Design Review Committee Agenda

RE: 40 Gold Dust Trail - Design Clearance for the remodel of an existing church
(APN: awaiting new APN)
Zoning: R-E
Design Standard District: Historic District
Applicant: JWCS Design

Approve, with conditions, a Design Clearance application for the proposed improvements at 40 Gold Dust Trail (Kingdon Hall of Jehovah's Witnesses), which is located within the Historic District.

Project: Sutter Creek Kingdom Hall Major Renovation
Address: 40 Gold Dust Trail, Sutter Creek, CA 95685
Subject: Response to Design Review Committee Questions

Figure 5 – Existing Windows (Source: JWCS Archive Photos)

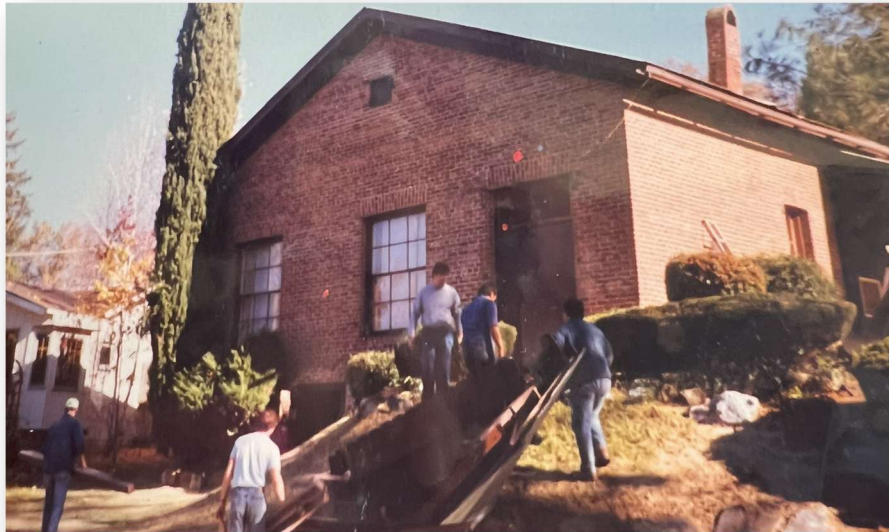
In 1991, the existing openings were closed and replaced with metal shutters (See Figure 5).

- **Exterior Wall Features.** The metal shutters and the front entry metal door will be removed and reused.
- **Front Entry Canopy.** The front entry canopy may be removed, if needed. If so, the front canopy is proposed to be restructured to mirror the existing canopy.

Figure 1 - 1991 Floor Plan: URM Building between Gridlines "A" and "B"

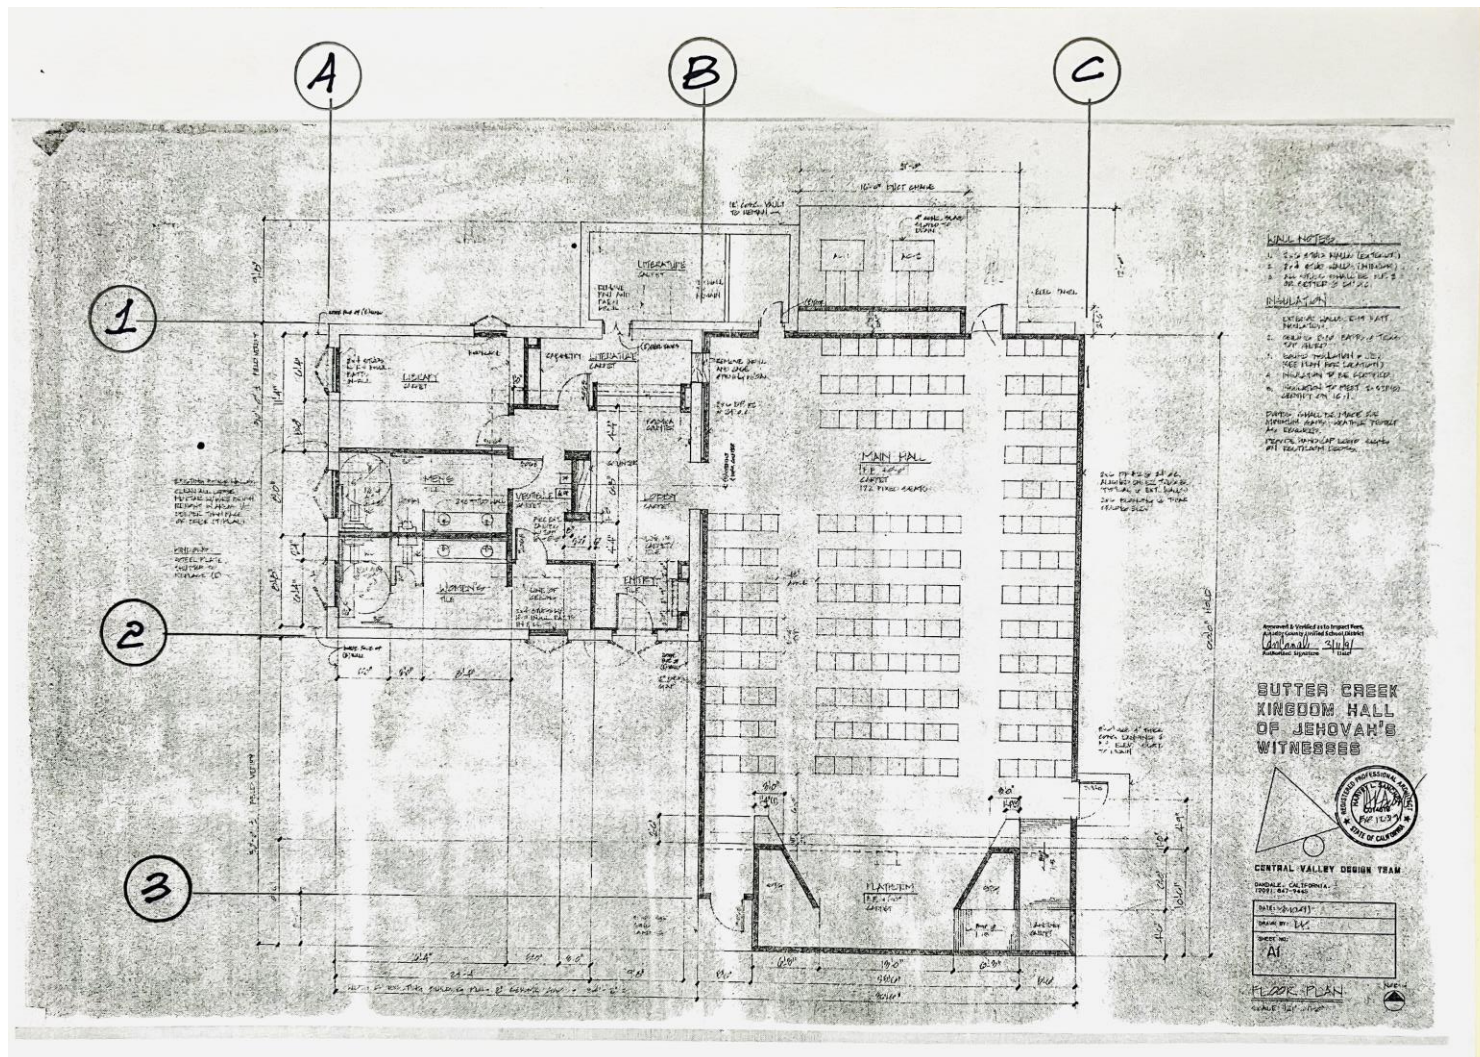
Sheet S2 of the plan set dated 3-10-91 (wood framed slab-on-grade addition) called for the addition of wall anchors at 4'cc at approximately 8'-8" above finished floor on three sides of the building. (Plate washer (see Pic 1) were observed on the exterior of the building at this elevation at spacings up to 8'-0".)

Detail 4/S2 called for the installation of 3x6 DF joists with Simpson LTT20 light tension ties with ½" diameter epoxied rods at 4'-0" cc along gridlines 1, 2, and A. Sheet S2 did not provide continuous ties, struts, or chords for the “Ceiling Framing Plan” diaphragm to resist the wall anchorage forces at the Simpson LTT20 locations. No structural sub-diaphragms or cross ties were detailed. No edge nailing was required at 3x6 tie locations.

Figure 2 - 1991 Ceiling framing plan with 1/2" plywood and Simpson LTT20 tension ties @ 4'-0" cc at URM walls

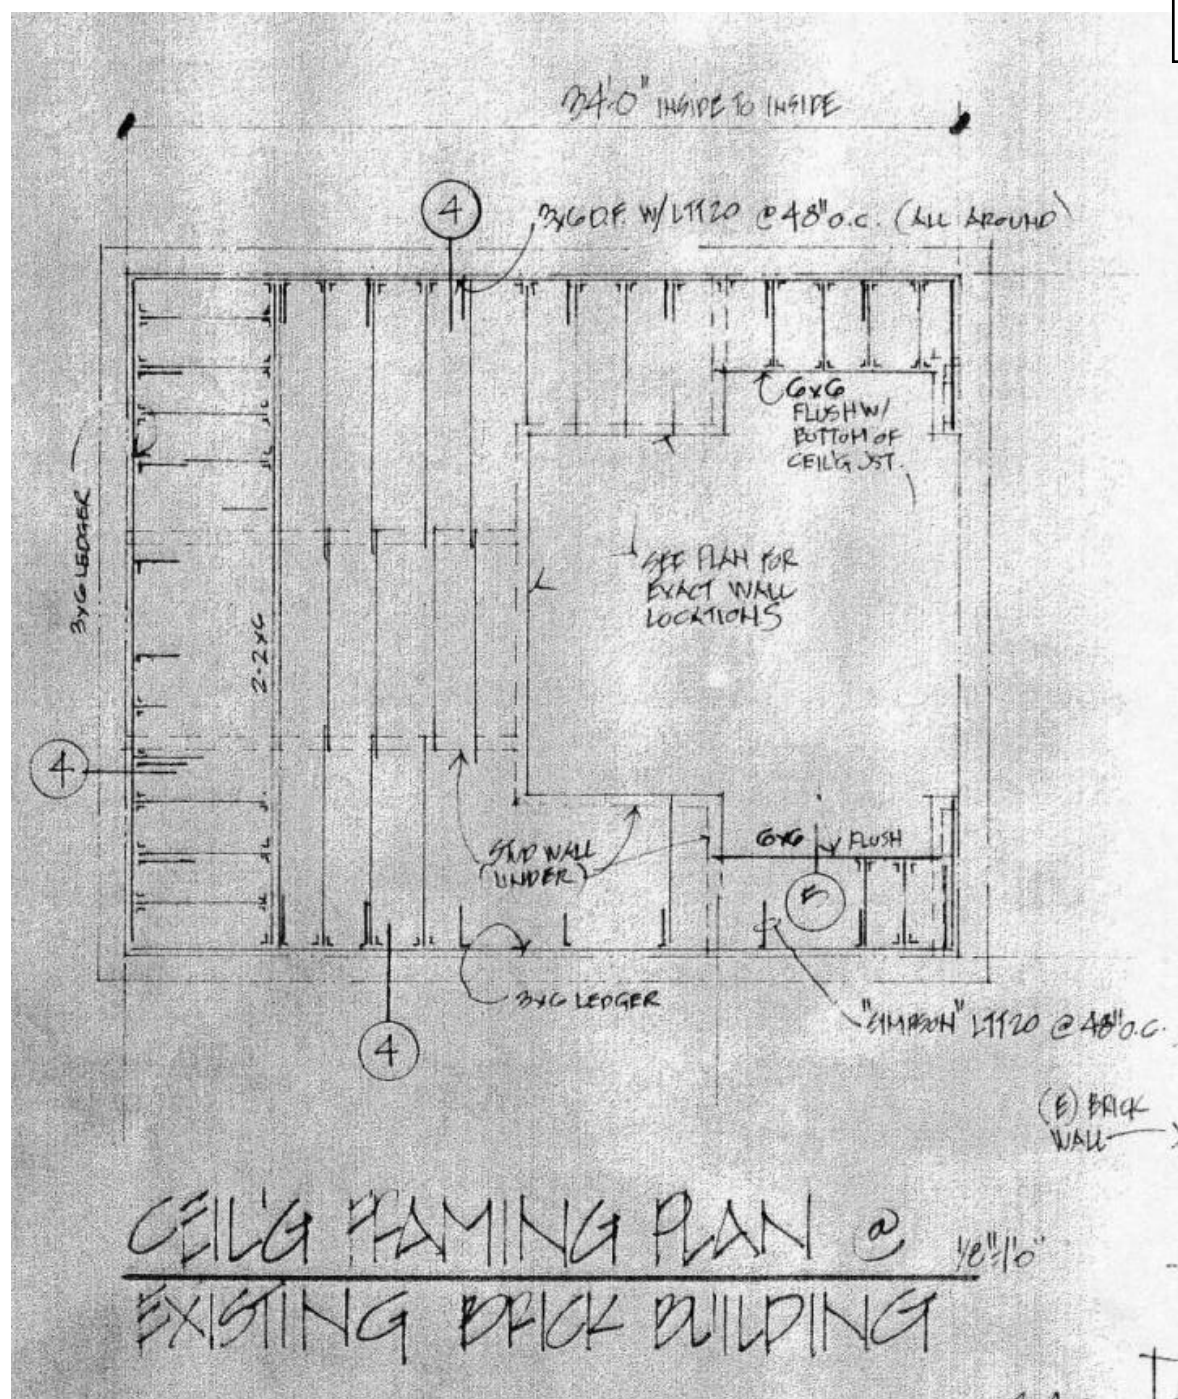
The Ceiling Framing Plan on Sheet S2 (See Figure 2) called for new 2x6 ceiling joists with ½" plywood installed on the top of a new hard lid ceiling over the rooms adjacent to Gridlines 1, 2, and A.
